ISSUE: Certificate of Appropriateness for new construction

APPLICANT: City of Alexandria and Washington Metropolitan Area Transit Authority (WMATA)

LOCATION: Old and Historic Alexandria District
2500 Potomac Greens Drive (2405, 2501, 3701 Potomac Avenue, 3251 Potomac Avenue [Parcel ID 016.04-01-01], 700 Carpenter Road, 1702 and 1880 Potomac Greens Drive) 2901 Potomac Avenue (2405, 2501, 3701 Potomac Avenue, 3251 Potomac Avenue [Parcel ID 016.04-01-01], 700 Carpenter Road, 1702 and 1880 Potomac Greens Drive)

Potomac Yard Metrorail Station

Figure 4: First floor plan of entrance pavilion, endorsed by BAR in 2016

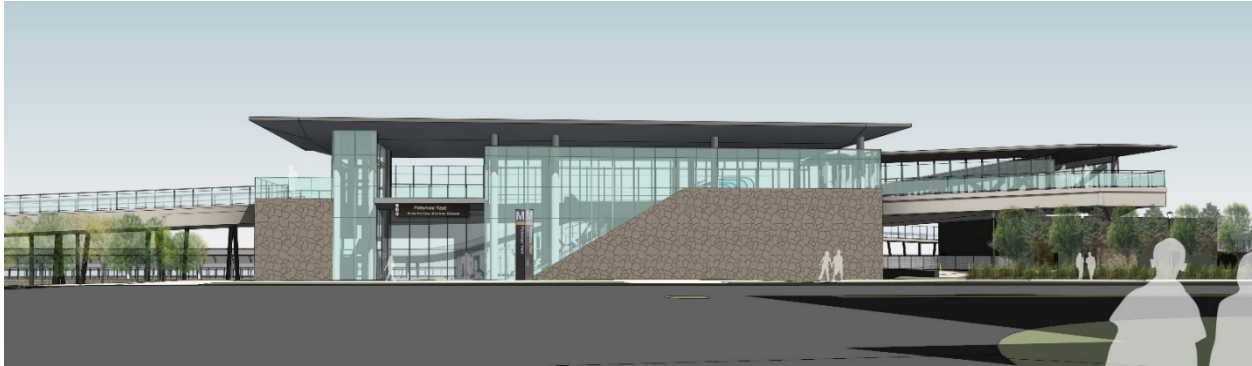
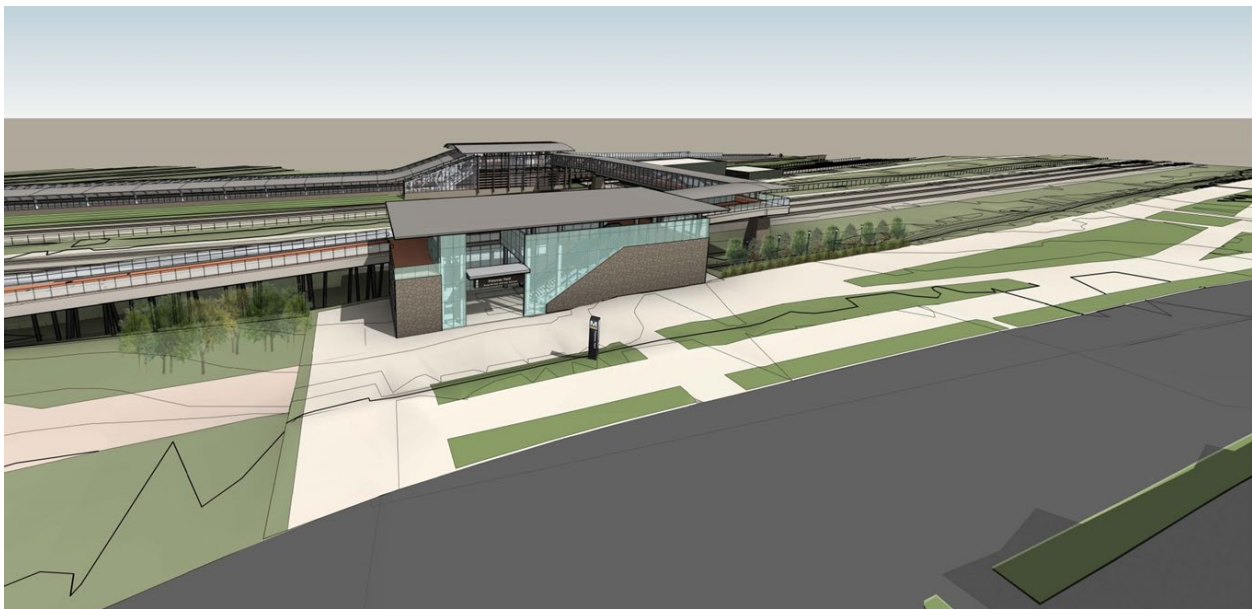
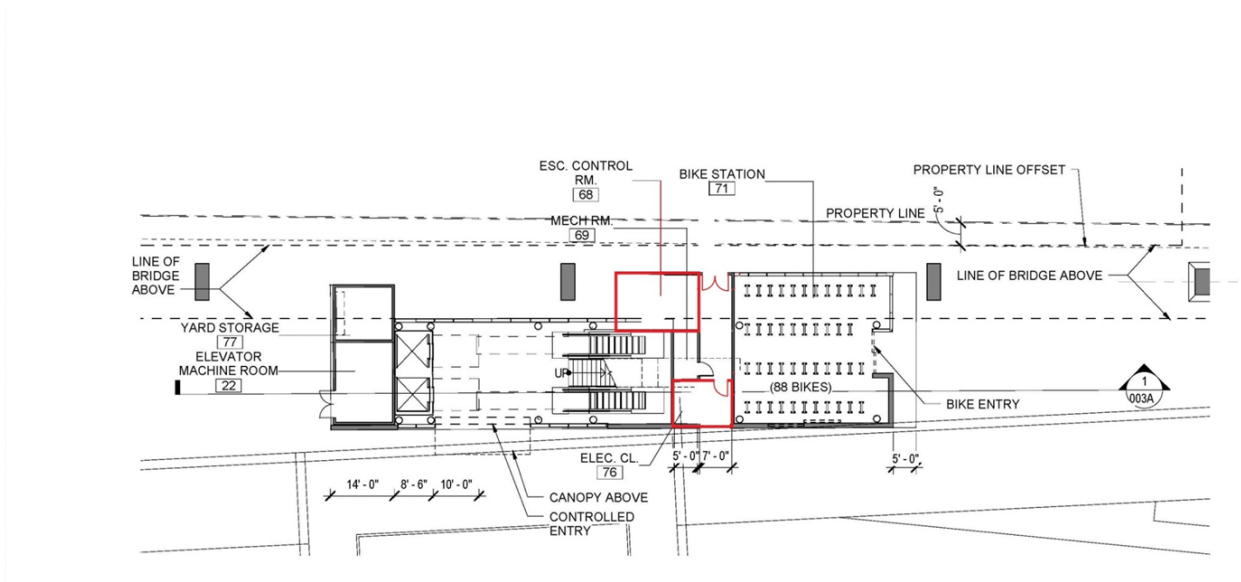
felt that there should be some unity of materials and details to identify this pavilion as the entrance to the Metro station. The shape of the roof was discussed, as was the stone walls and their slope reflecting the escalator. Images of the BAR's previously endorsed pavilion are shown in Figures 1-4 below.

However, the architectural details of the pavilion have not been advanced from the concept review. For instance, no lintels are shown over the openings in the fieldstone walls. While longer pieces of cut stone may have visual structural support, fieldstone does not. Staff suggests that either lintels be expressed or the stone for the entrance be the same stone as the station but in a random ashlar pattern. In addition, there is no coping shown at the top of the stone walls. It is also not clear from the soft colored renderings what the mullion and support system is for the glass walls. These fundamental architectural details on the exterior of a structure are a normal part of the BAR's review.

1. Approval of the footprint, scale, mass and architectural character and materials of the pedestrian bridge, ramp and entrance pavilion with a restudy of:
 - a. The lighting and handrails in the pedestrian bridge; and
 - b. The architectural details of the entry pavilion to include, at a minimum, lintels over the fenestration, caps at the stone walls, the color, material and design of the window wall framing members.
2. Approval of the rafters of the pedestrian bridge with a restudy of:
 - a. The number and method of attachment of the handrail/guardrail system; and
 - b. The lighting fixture location and any visible utility conduit must be shown in the renderings.
3. Approval of the architectural lighting with final review by staff to confirm that it is:
 - a. Directed away from the GW Parkway;
 - b. That the color is 3,000 Kelvin or warmer.

7. Restudy the proportions, connections and construction details of the following:
- a. The roof structure above the pedestrian bridge trusses;

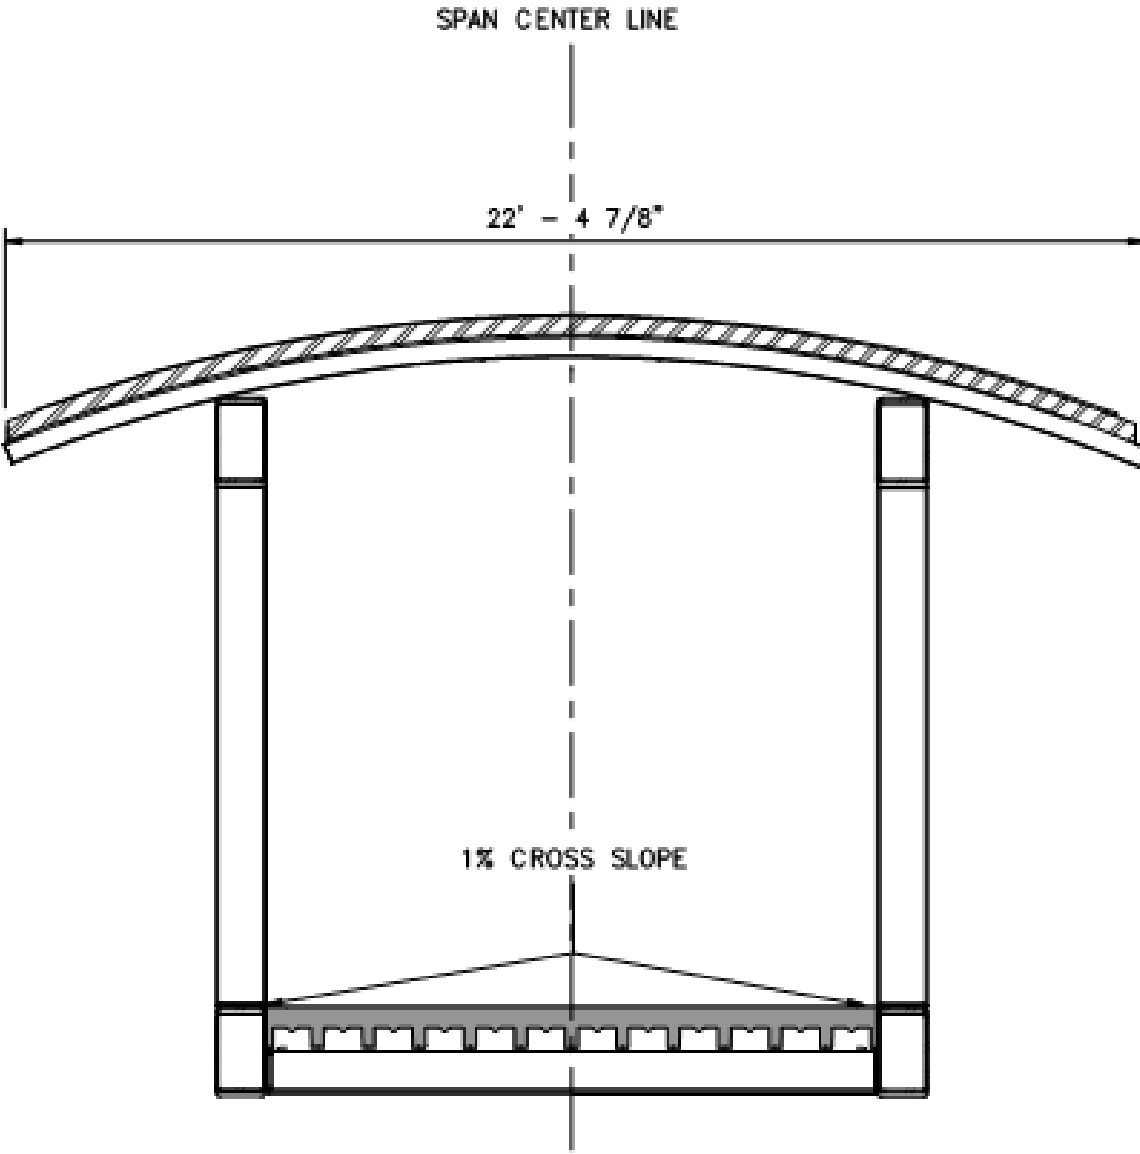
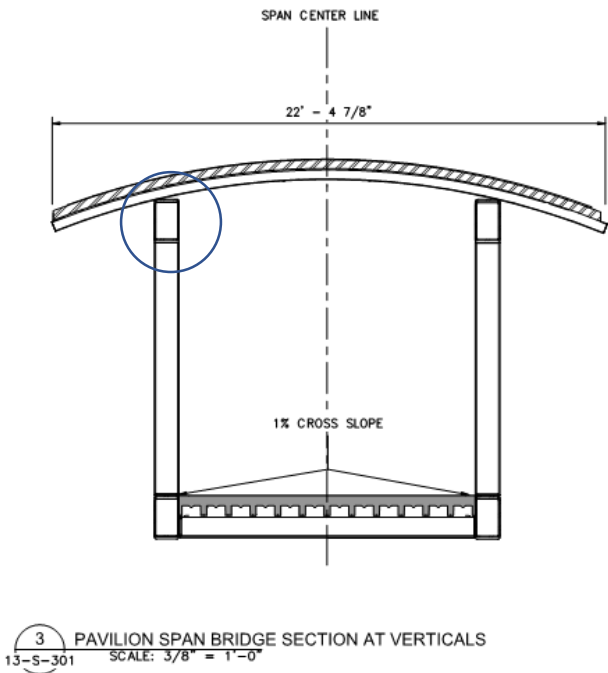
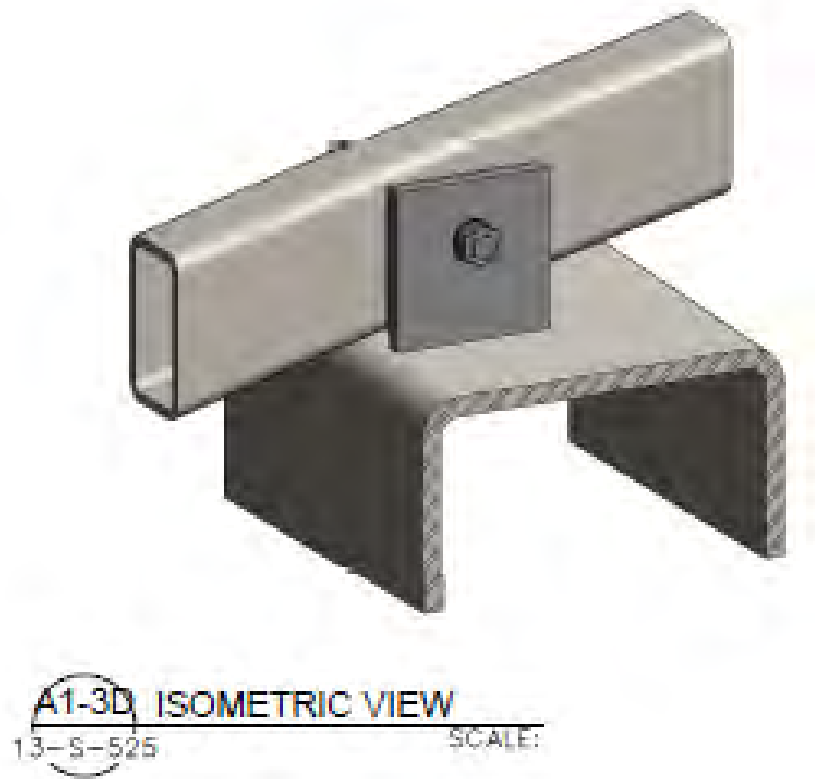
The applicant has resubmitted illustrations of the roof of the pedestrian bridge. The BAR had found that the previous baby trusses were poorly proportioned and did not satisfactorily reference the large curved trusses of the station. The revised submission removes the lower chord and simply shows curved rafters in a light grey color. The ceiling material has not changed. Staff finds this to be a much improved solution that relates to the chords of the trusses on each side and provides a pedestrian scale rhythm for the long walk over the rail tracks.

Item	Status
7.	Restudy the proportions, connections and construction details of the following:	
a.	The roof structure above the pedestrian bridge trusses;	Open – to be presented at tonight’s meeting

b. The visual transparency of the guard fencing on the pedestrian bridges and whether this should be installed on the inside or the outside of the bridge truss elements;

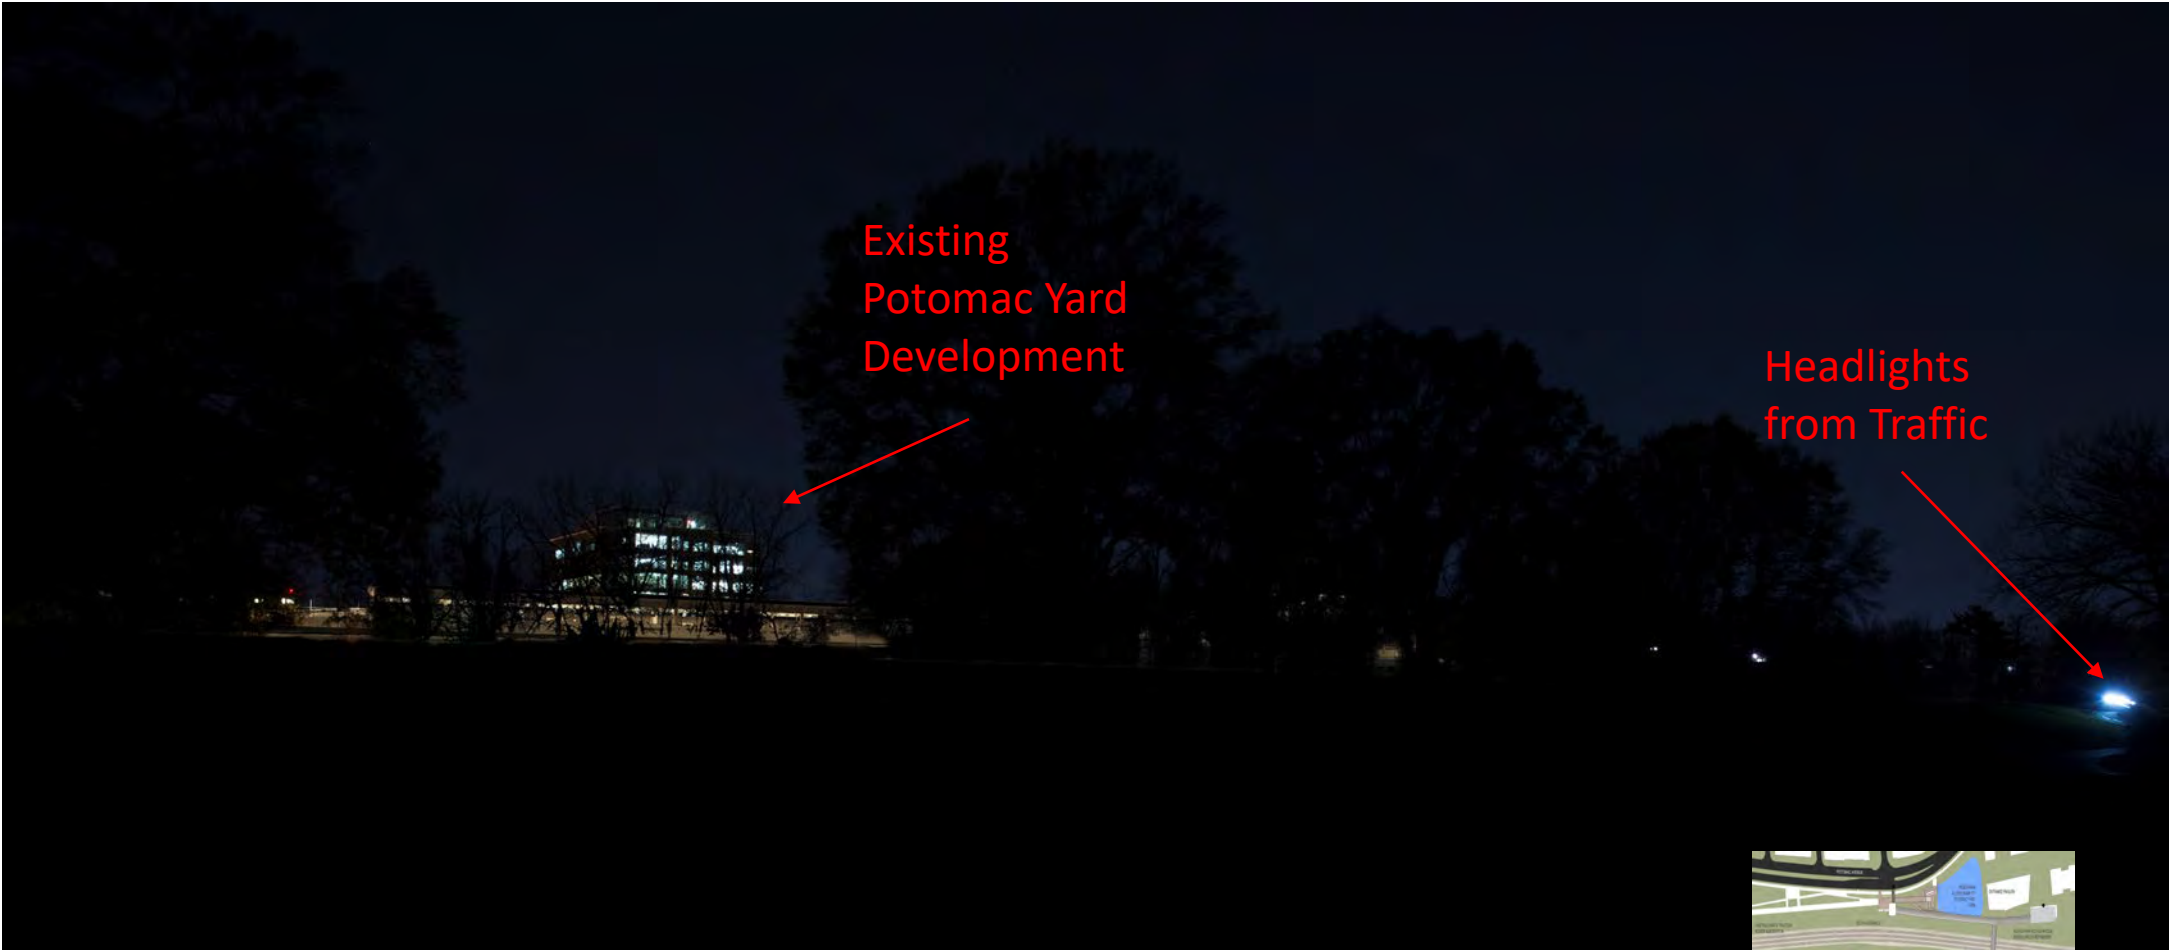
However, the number of handrails required by code and how they will attach to the floor and/or truss have not been resolved and these will be provided at a later date. Light fixtures and conduit are not shown in these renderings and these, too, will have to be provided at a later hearing.

b.	The visual transparency of the guard fencing on the pedestrian bridges and whether this should be installed on the inside or the outside of the bridge truss elements;	Open – to be presented at tonight’s meeting
